Proposal how to structure the RESS safety requirements

<JASIC Comment>

Remarks from Korea:

Figure 7:

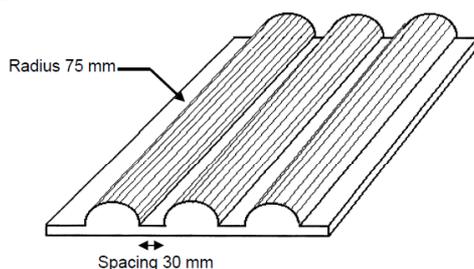
Crush a [RESS or pack(s)] between a resistance and a crush plate described in figure 7 with a force of [100 kN] ~~[X seconds; how fast]~~ during [Y seconds; how long] at least 100 ms should be limited to a duration of [100] ms in direction of travel and horizontally perpendicular to the direction of travel of the [RESS].

[Dimension of the crush plate:

600 mm x 600 mm or smaller

Orientation of the crush plate:

The orientation shall be agreed by the manufacturer and the Technical Service.

Position of the crush plate:

The position shall be agreed by the manufacturer and the Technical Service.]

Figure 2

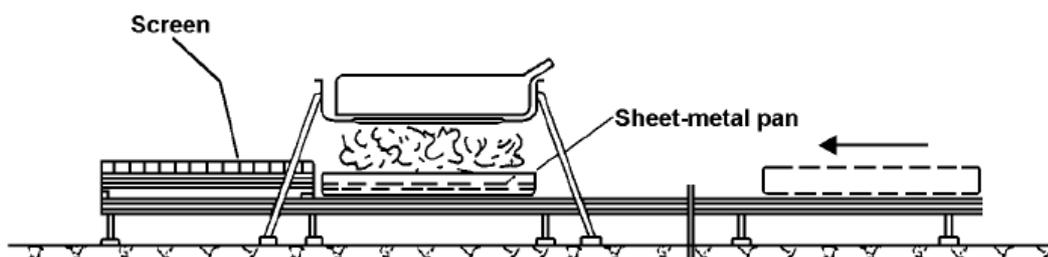
For 90 70 seconds the [RESS] shall be exposed to the flame from the freely burning fuel.
